PROJECT: Summerlin West V25 - Scarry Blvd Drive Improvements

SUBMITTAL: 2nd

CITY OF LAS VEGAS		DATE:
INTER-OFFICE MEMORANDUM		May 5, 2021
TO: Land Development Services Department of Building & Safety		FROM: Albert Sung, P.E. Flood Control Project Engineer Department of Public Works
SUBJECT:	Drainage Study for:	COPIES TO:
Summerlin West V25 - Scurry Bend Drive Improvements (from Sunset Run Dr. to Lake Mead Blvd.)		Atkins
Cross Streets:	Scurry Bend Drive. & Lake Mead Boulevard	Howard Hughes Company, LLC
File Number:	F:\Depot\DSMemos\DS5427B.doc	Bart Anderson, P.E., DevCo
Parcel Number:	137-15-801-002 & more	
Zoning Action:	N/A	
FEMA Flood Zone	YES NO X	
Proposed Storm Drain	YES X NO

Summerlin West Village 25

DESIGNED BY: B. MOCHTYAK	DATE: APRIL 2021	DRAWING NO. 12/42
DRAWN BY: K. HENDRY	DATE: APRIL 2021	DRAWING NO. 12/42
CHECKED BY: N. BARCOS	DATE: APRIL 2021	DRAWING NO. 12/42
APPROVED BY: NICOLAS BARCOS	DATE: APRIL 2021	DRAWING NO. 12/42

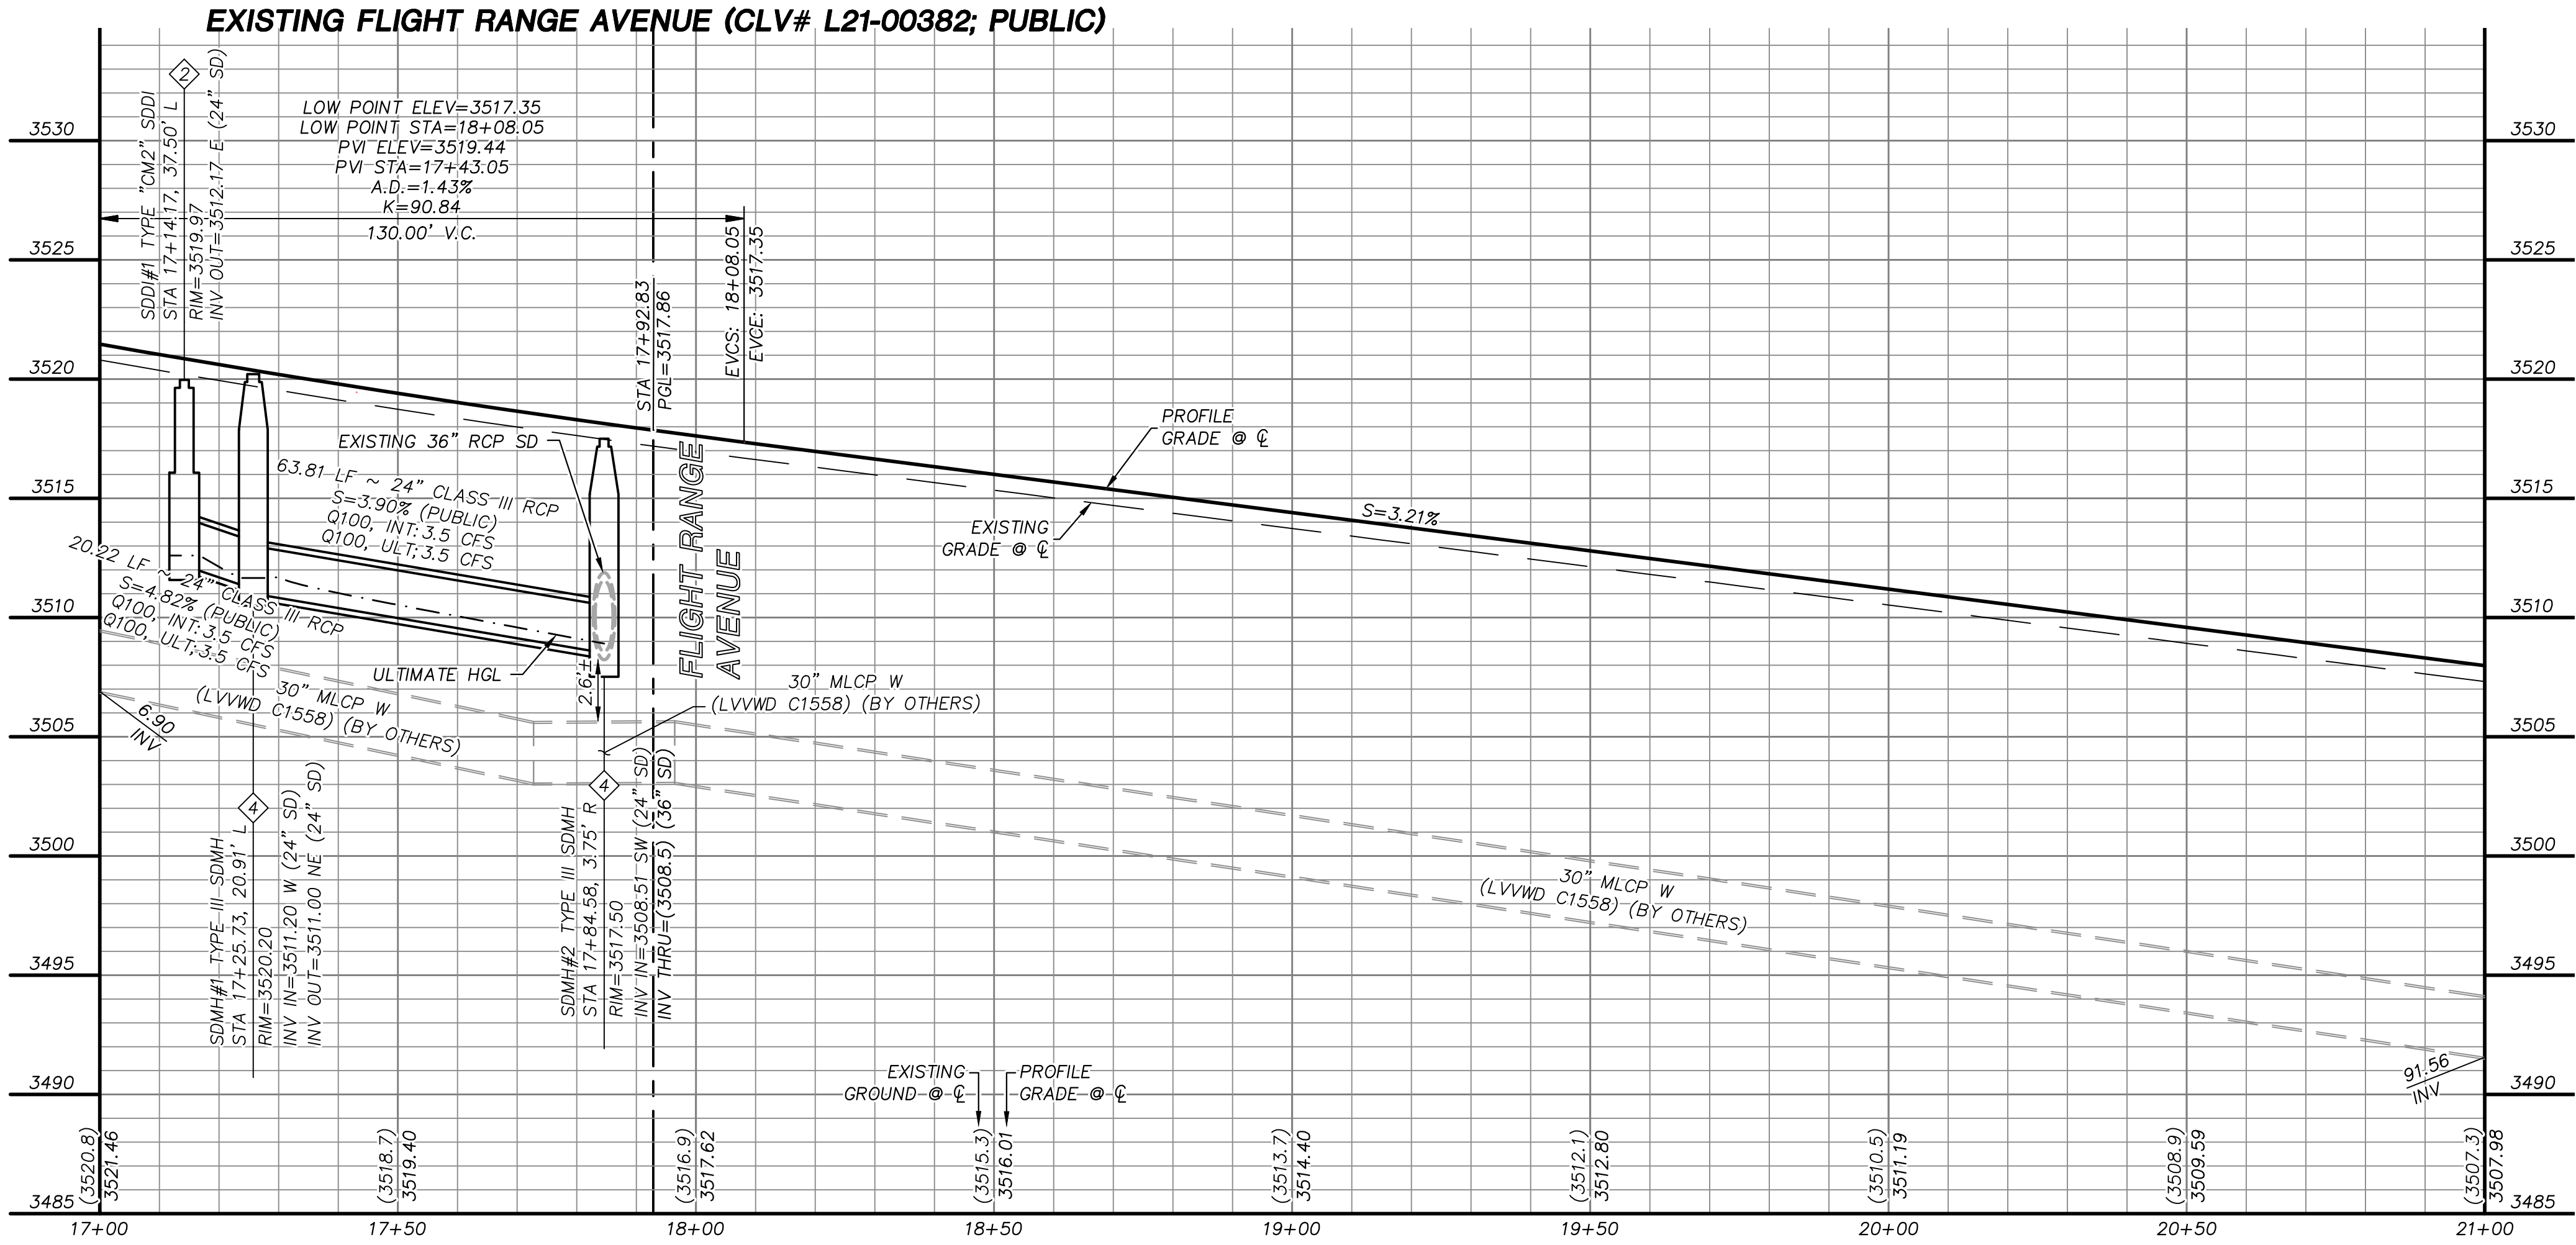
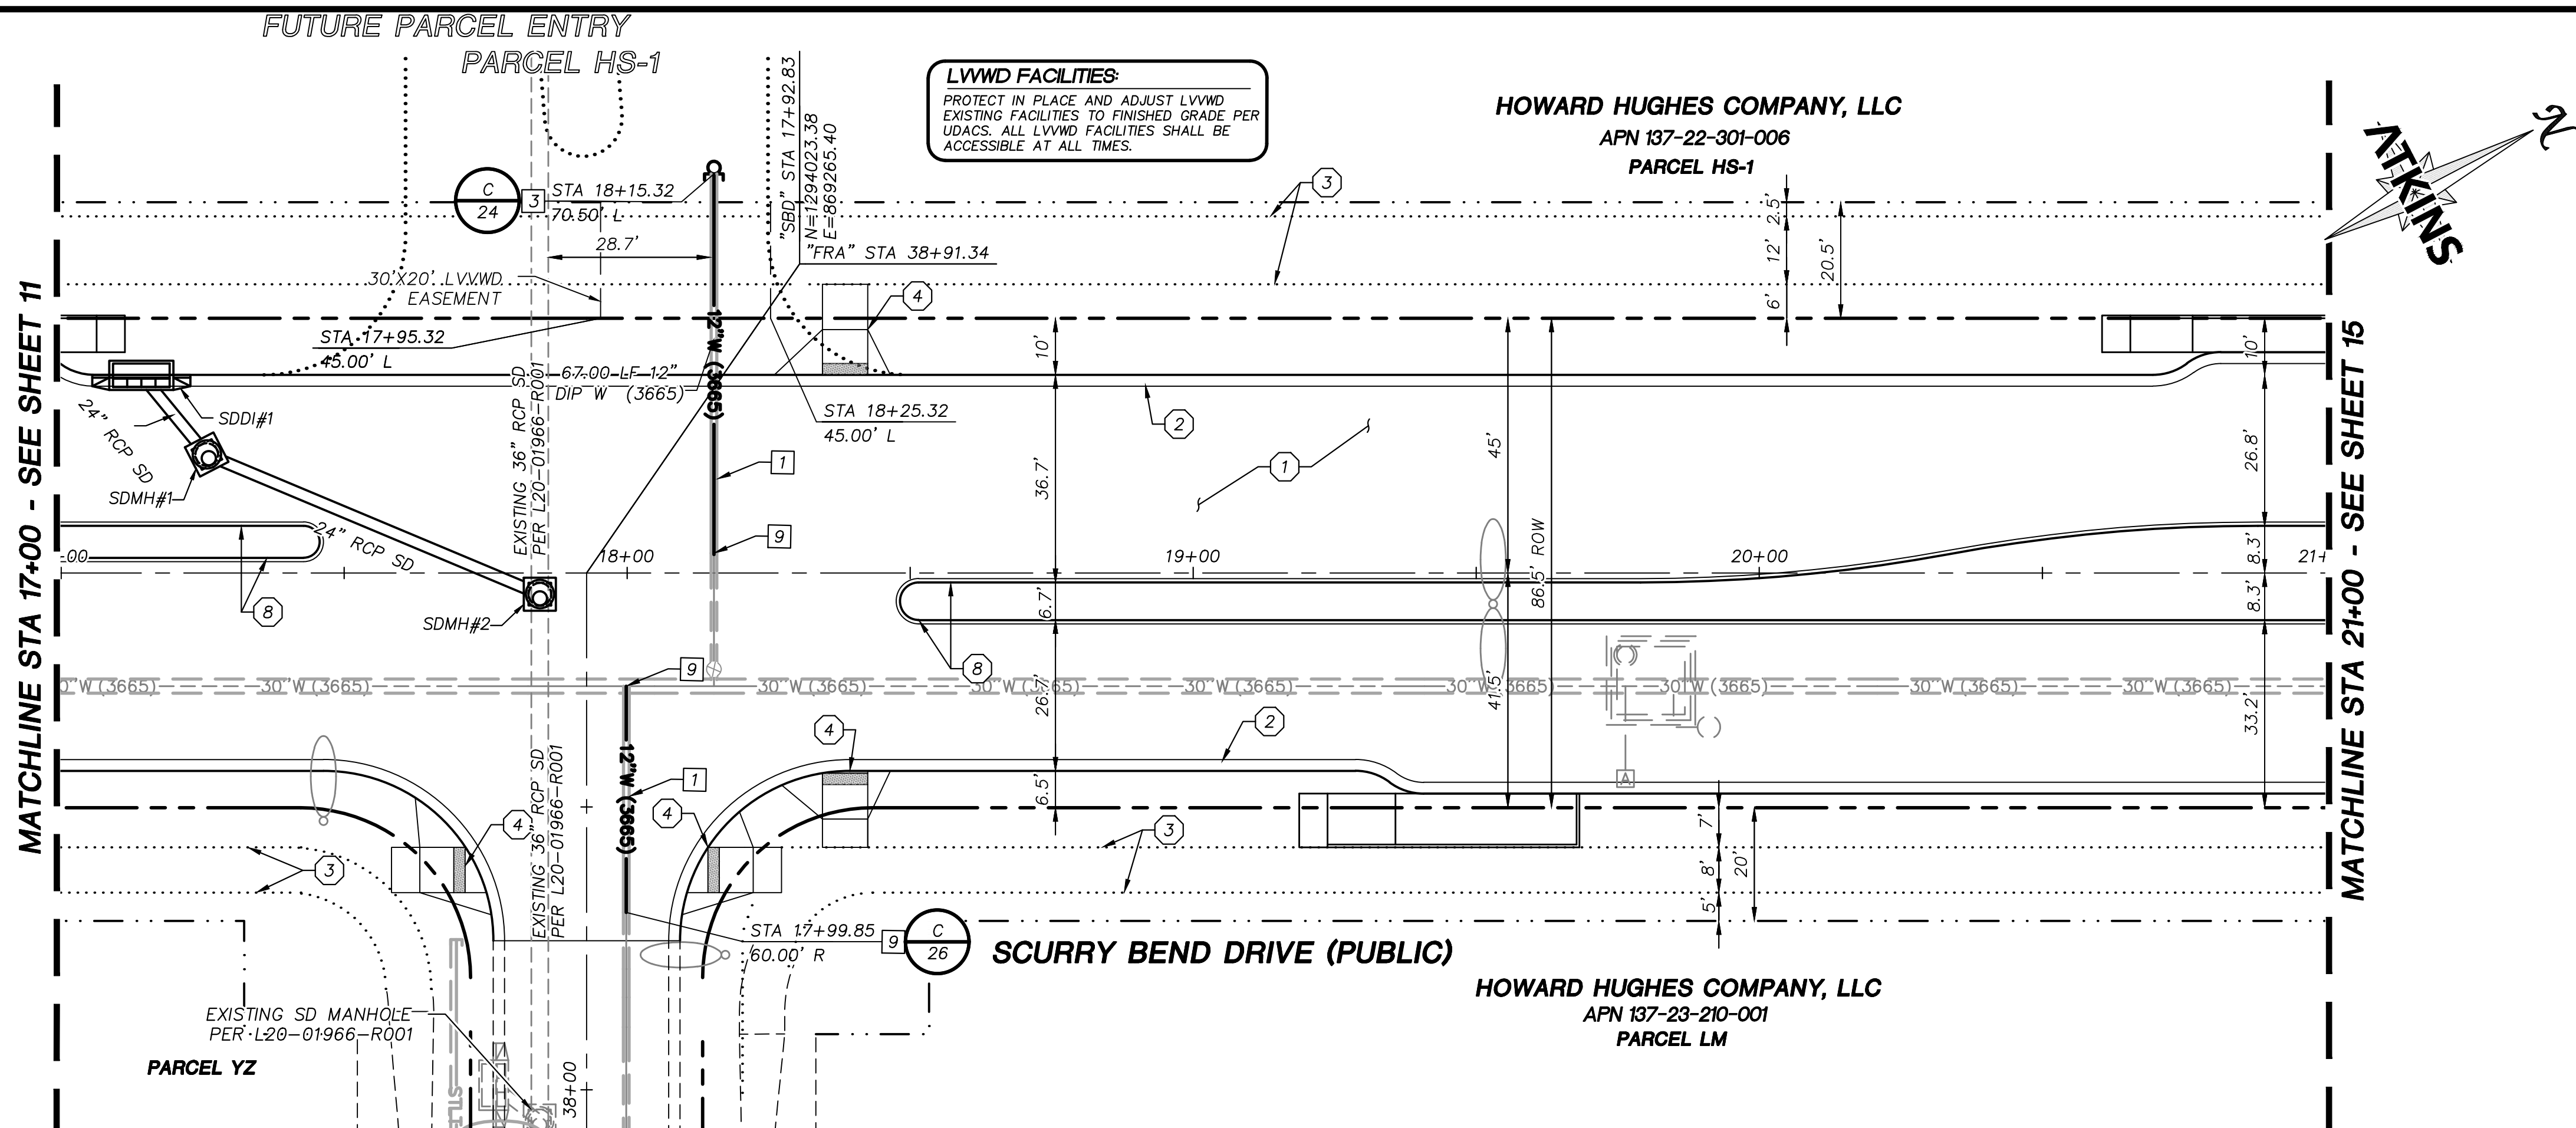
Comment #10: *Roadway plan and profile Sheet 12/42 and Sheet 13/42 inlet SDDI#1 curb transition is located in the pedestrian curb ramp. Revise so that these do not overlap.*

Comment response: The improvement plans have been revised so that there is no conflict with the drop inlets and the pedestrian curb ramps.

DESIGNED BY: B. MOCHTAK
DRAWN BY: K. HENDRY
CHECKED BY: N. BARCOS
DATE: APRIL 2021
DRAWING NO. 13/42
VERT.: NONE

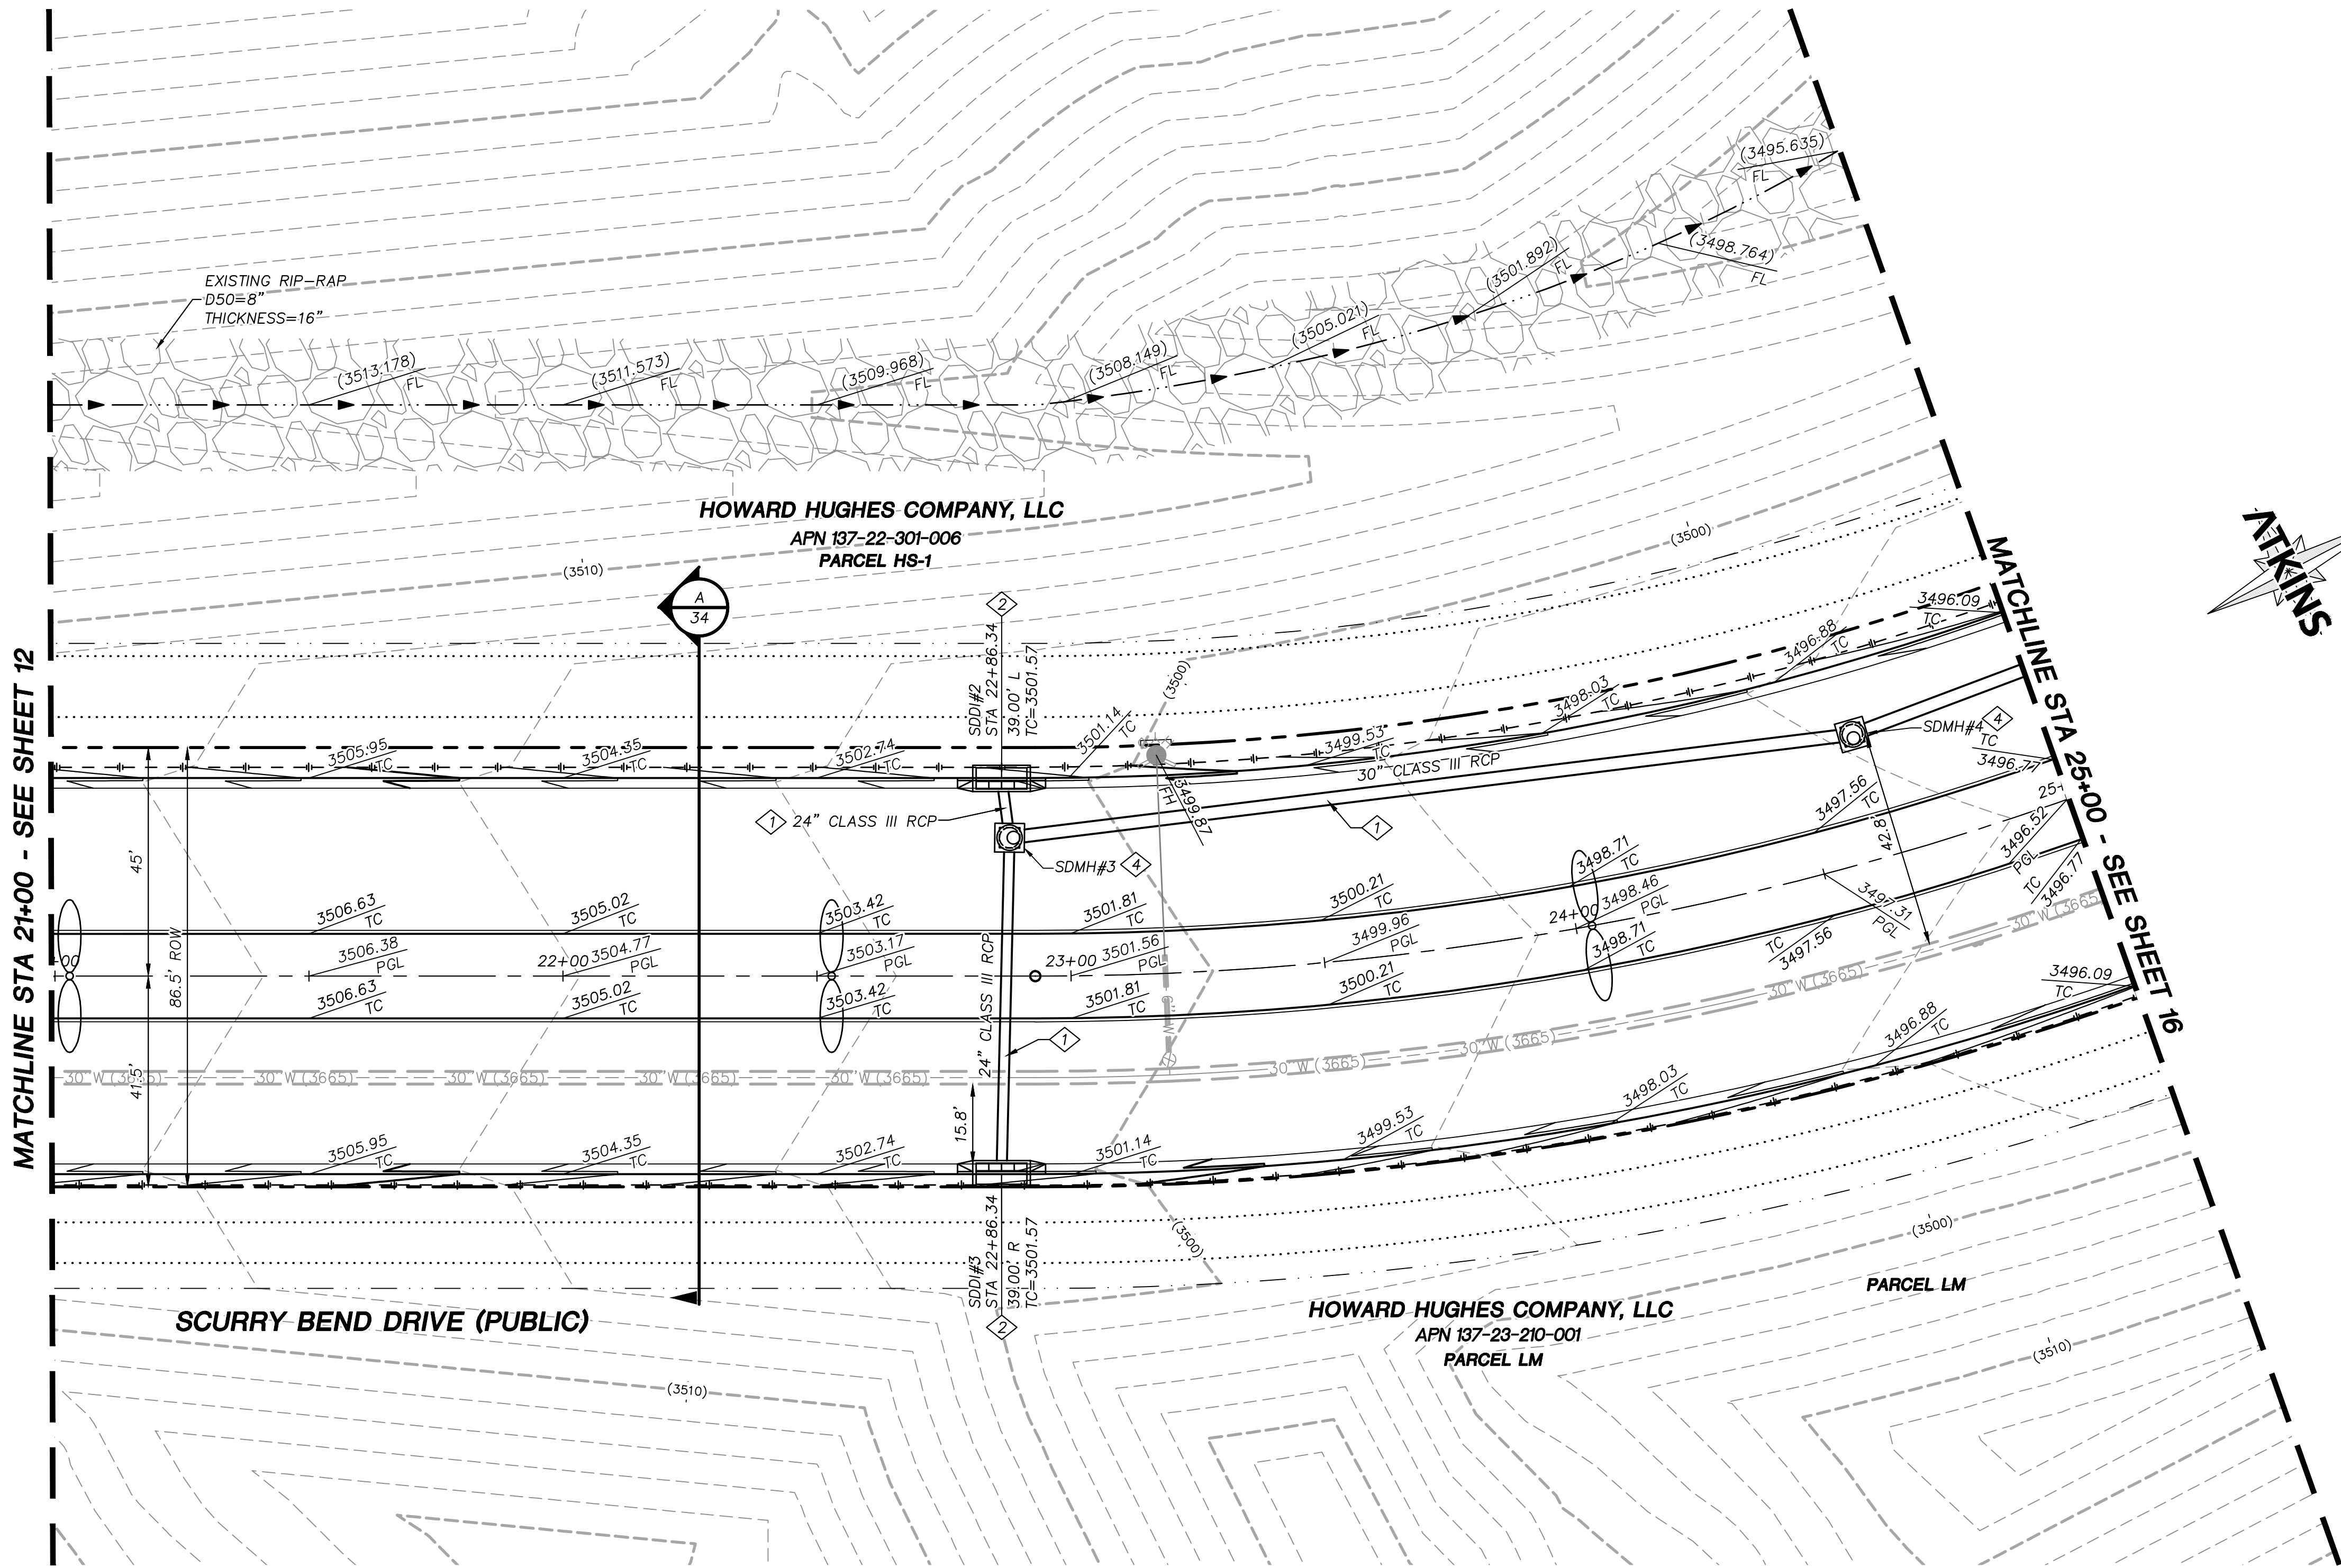
Comment #11: *Show the HGL for the lateral pipe for SDMH#1 on plan / profile Sheet 13/42.*

Comment response: The improvement plans have been updated with the HGL.
